FURTHER INFORMATION RESPONSE

APARTMENT DEVELOPMENT AT HAYDEN'S LANE, LUCAN CO DUBLIN.

DLRCC REG. REF:	SD21A/0359
DATE OF REQUEST FOR FURTHER INFORMATION:	24 TH OF JANUARY 2022
FINAL DATE TO RESPOND TO REQUEST:	22 ND OF JULY 2022

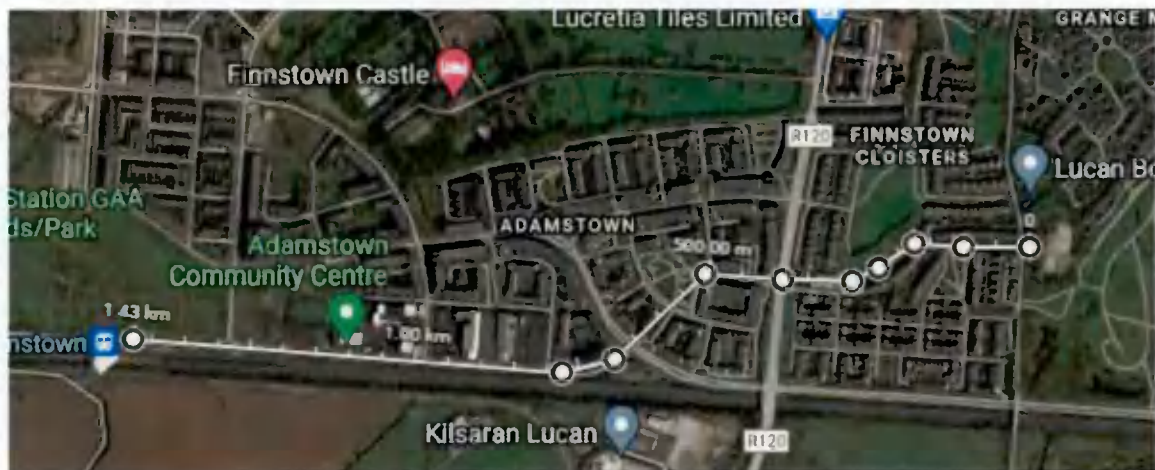
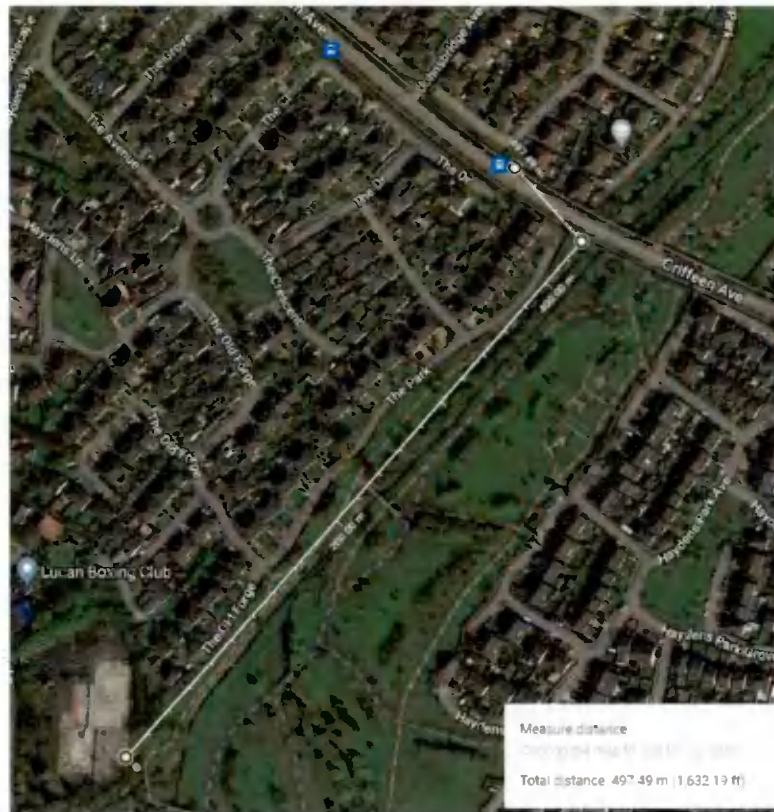
The Planning Authority has concerns in regard to the subject site's ability to support a proposed density of 68 units per ha (gross)/85 units per ha (net). The Planning Authority considers that the site does not have appropriate access to existing public transport and local facilities and services to support the proposed density. The Planning Authority has concerns that the site is not located within a reasonable and useable walking distance of a town or suburban centre, employment location or high frequency public transport. Some existing routes are also not considered appropriate. The overall limited access to public transport services is a concern. The applicant is requested to submit a revised proposal with a reduced density more appropriate to the site's context.

In response it is noted that the quantum of residential development proposed has been reduced by 11% to 66 units. The density of the development therefore also reduces to 60 units per ha gross / 75 net.

We refer again to the *Sustainable Urban Housing: Design Standards for New Apartments (2020)* and refer to Section 2.4 which defines 3 locational topologies for considering higher density apartment development.

Intermediate Urban Locations are identified as follows:

In this regard we note that the subject site will be accessible to Adamstown train station to the west and a number of bus routes in the area and in particular the C1 route between Adamstown and Sandymount via the city centre with frequency every 15 mins at peak. These are mapped out using Google Maps on the images below.
